**Proposal for amendments to the Consolidated Resolution**

**on the common specification of light source categories (R.E.5)**

## **Proposal for Amendment 9 to the Consolidated Resolution on the common specification of light source categories (R.E.5)**

### **Submitted by the Working Party on Lighting and Light-Signalling\***

Figure 1\*  
Main Drawing

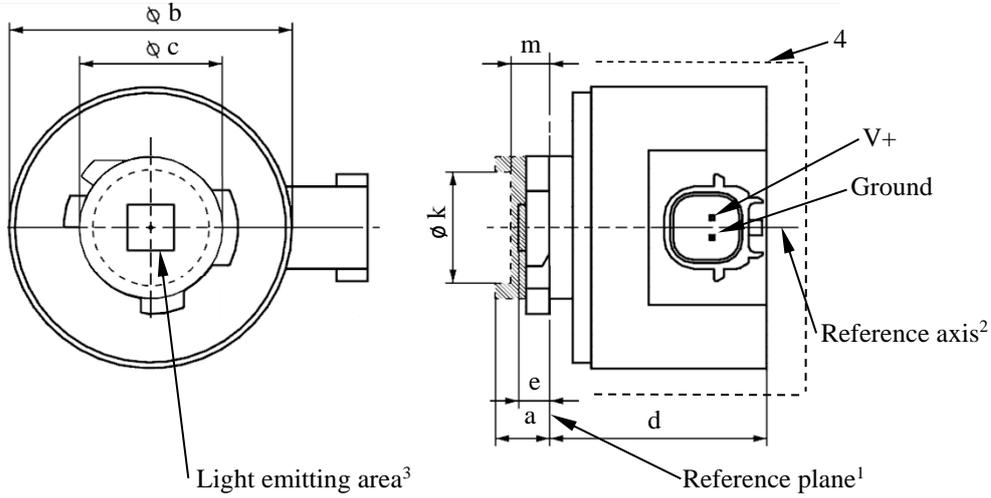
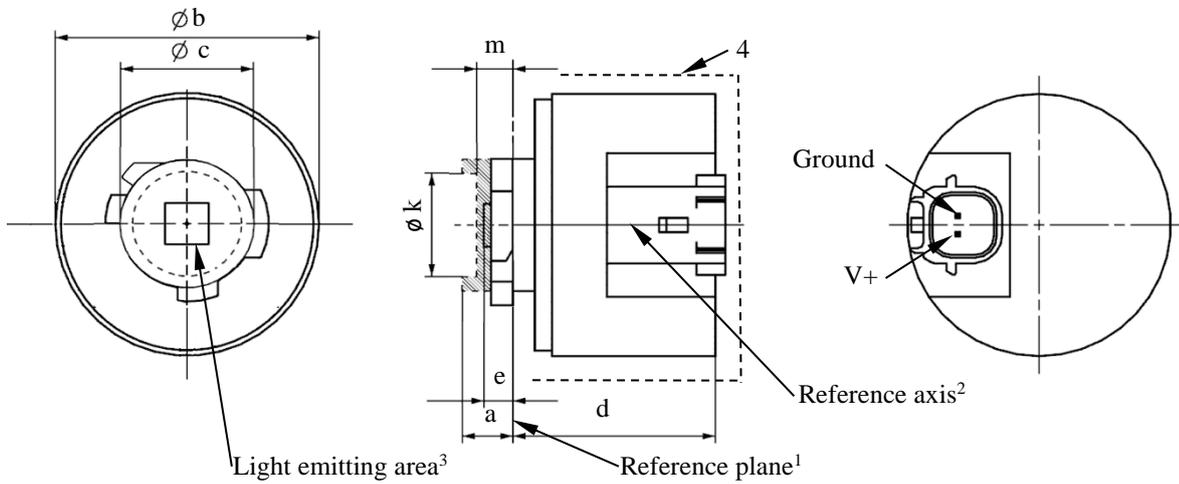
*Annex 3, Sheets Lx6/1 to 6, amend to read (see following pages; one page per sheet):*

Set-up to measure the luminous intensity distribution

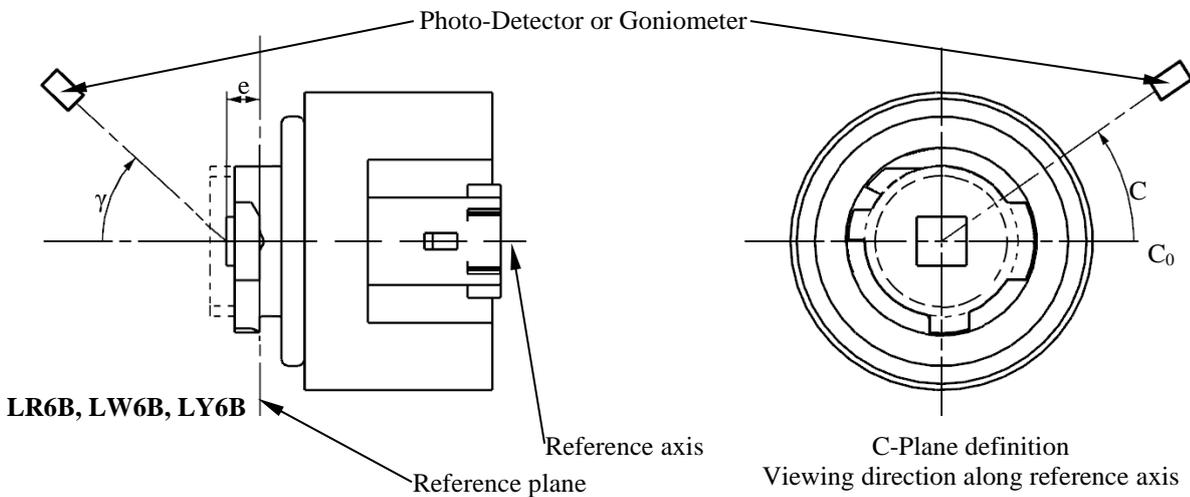
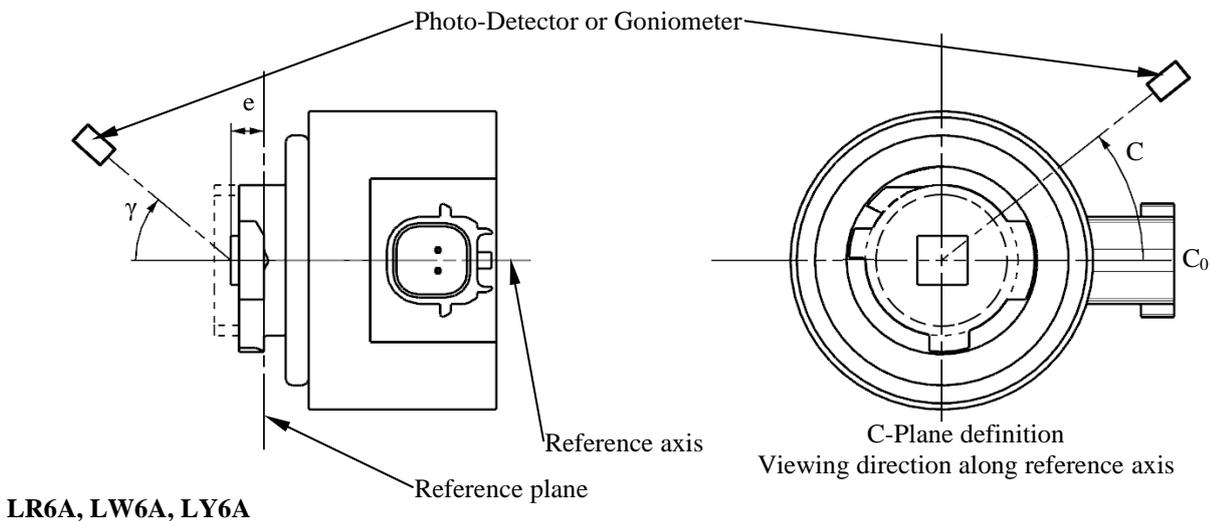
The light source is mounted on a flat plate with the corresponding mounting lug features. The plate is mounted to the goniometer table by a bracket, so that the reference axis of the light source lines up with one of the rotating axes of the goniometer. The corresponding measurement set-up is described in Figure 3.
